DESIGN REVIEW BOARD

Thursday, June 8, 2023, 2:00 P.M.

**A. Beaufort Senior Apartments, PIN R122 029 000 0625 0000, 1556 Salem Road.
Applicant: Michael Riley, Architect (23-02 DRB.3)**

STAFF REPORT: 1556 Salem Road Site Plan/Senior Housing

CONCEPTUAL SITE PLAN

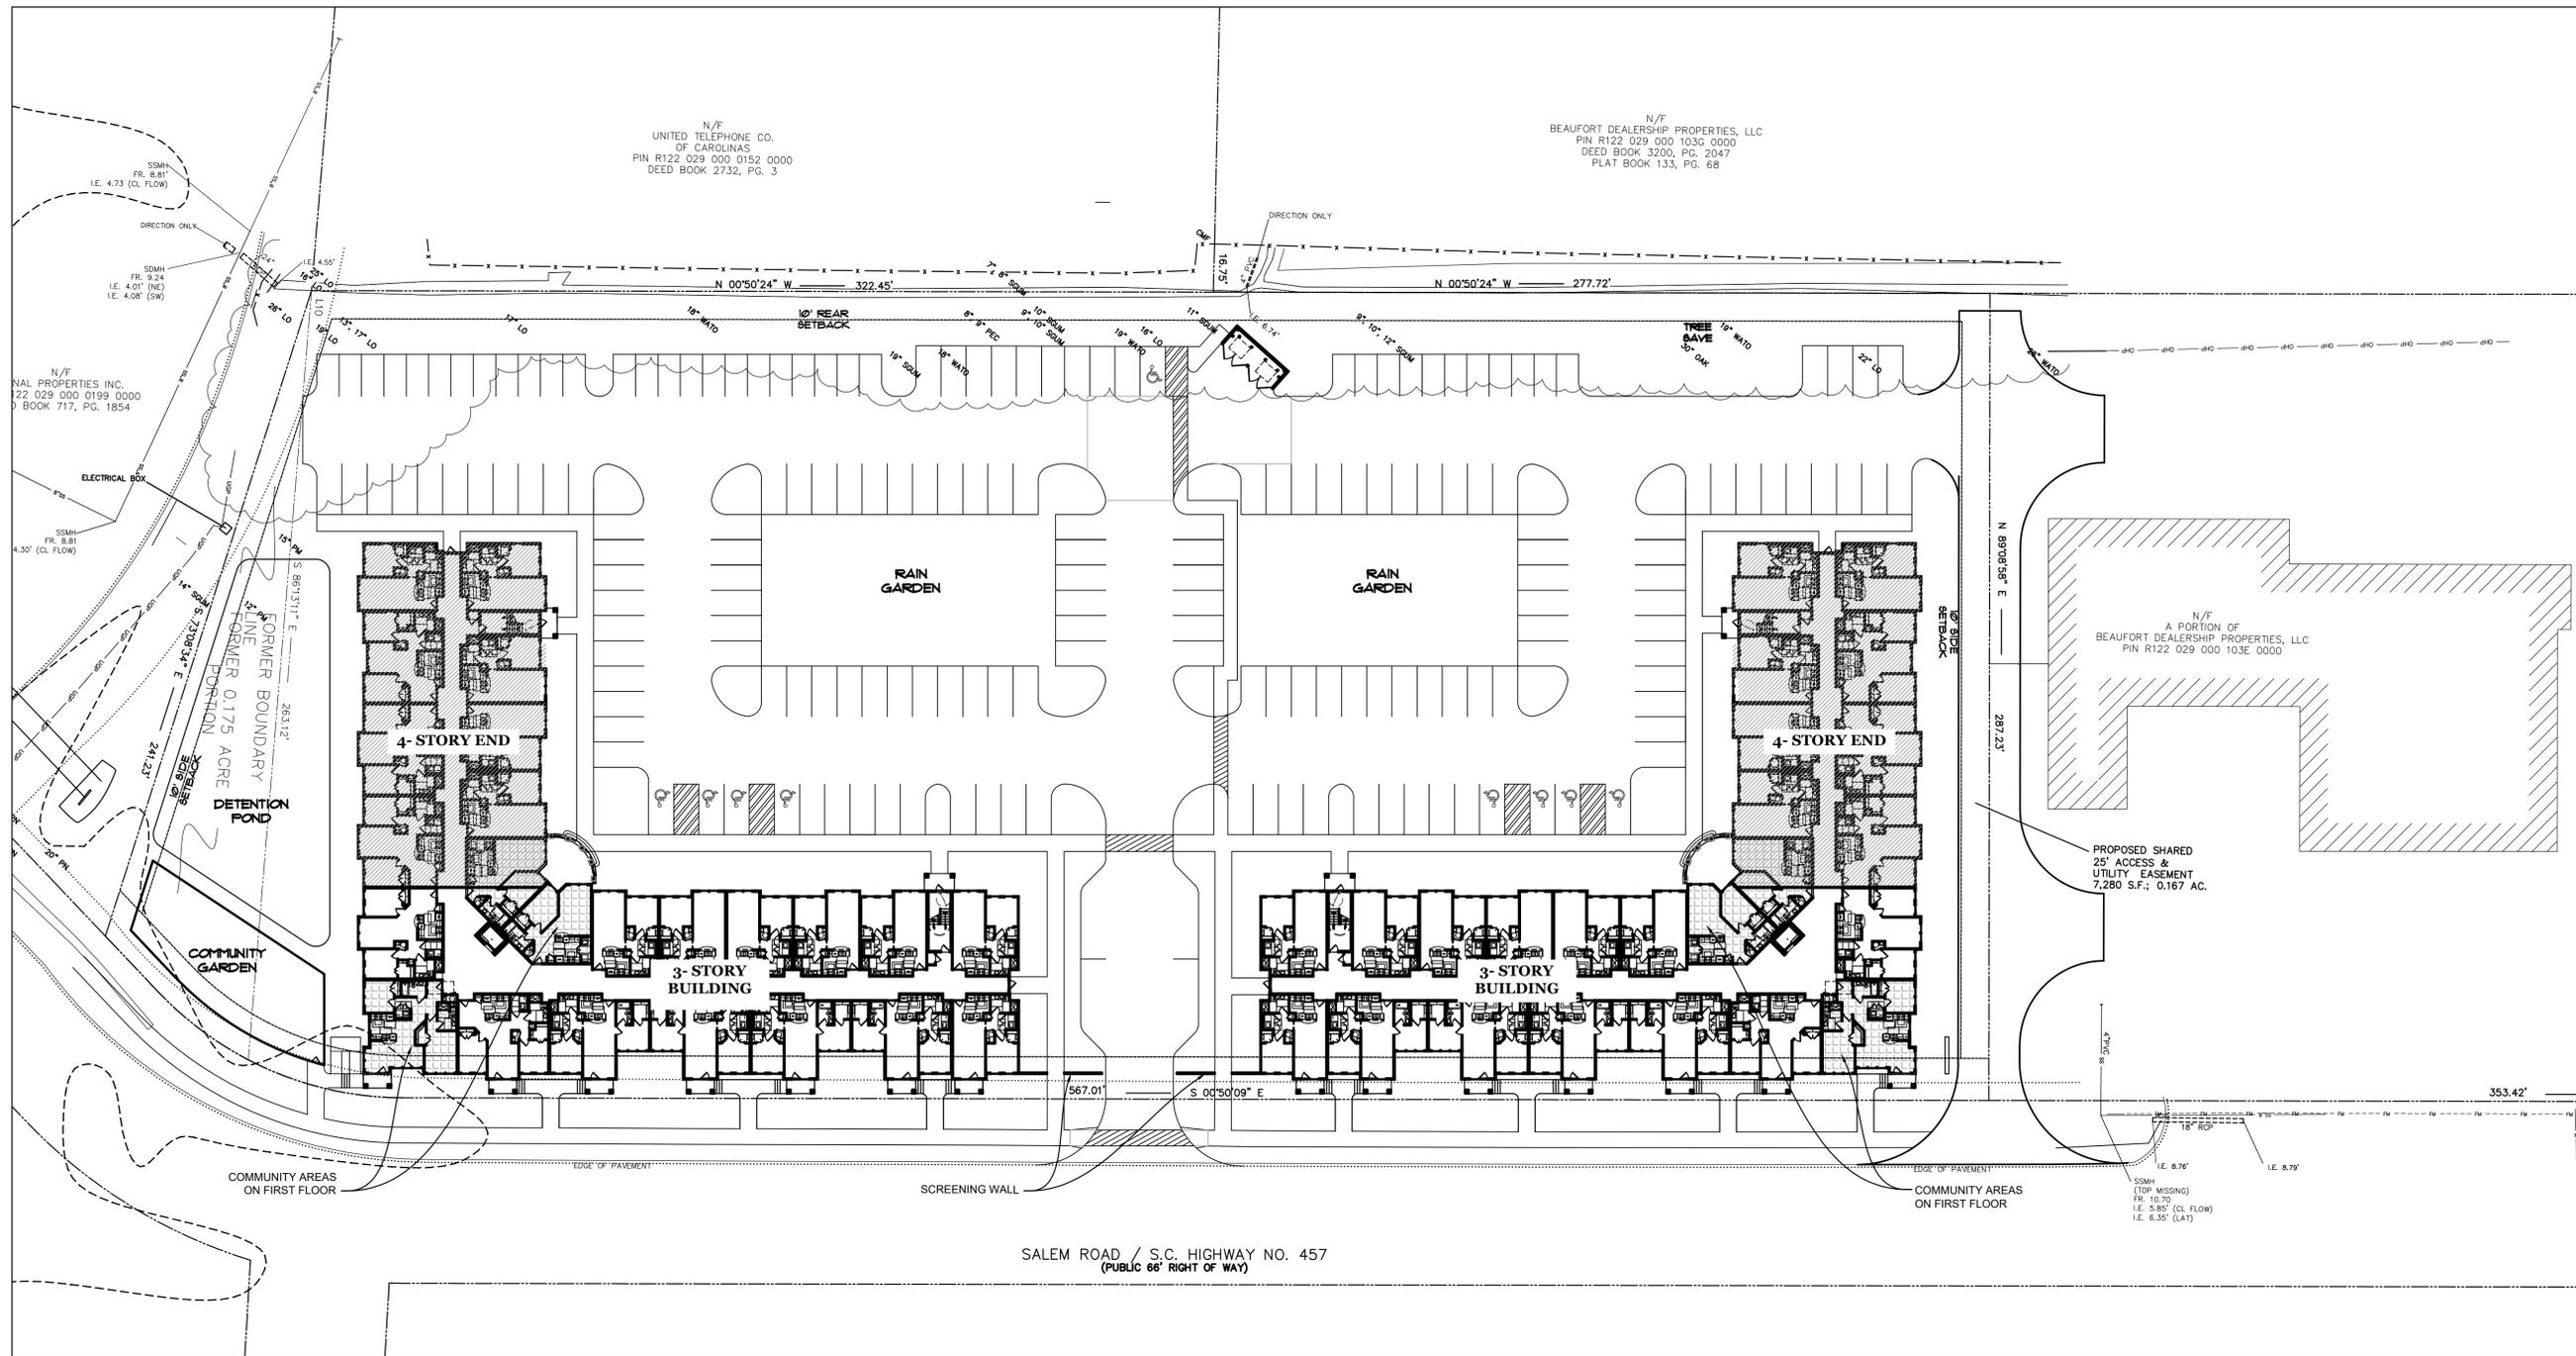
The Applicant is proposing to build two entrance points at the center and North end of the property. They have moved the proposed Southern entrance due to Staff concerns about visibility and safety on the sharp curve. The Northern Entrance would be a shared access drive with the adjoining Northern property.

Amenities: A community garden is planned for the Southwest corner next to the access point. There is also a small gazebo in the center of the lot.

Staff has concerns that the scale of the building is too large for the surrounding area and does not fit the neighboring context. Per Section 4.3.2, “Monolithic massing that disrupts the predominant building pattern of the neighborhood and corridor is strongly discouraged.”

-
- x. Staff has concerns that the scale of the building is too large for the surrounding area and does not fit the neighboring context. Per Section 4.3.2, “Monolithic massing that disrupts the predominant building pattern of the neighborhood and corridor is strongly discouraged.”

- ✓ **The community garden and gazebo relocated to a central location behind the buildings.**
- ✓ **The parking stalls on the center access point be removed and turned into tree lawn/open space.**
- ✓ **Screening along the perimeter be included, with opaque screening to the South.**
- ✓ **Consideration of a reduction in total parking spaces**
- ✓ **Consideration of specific architectural comments provided by Meadors for Final approval.**
- ✓ **Consideration of whether the four-story wings are necessary for the success of the project, and whether or not a three story product would be more in keeping with the area.**
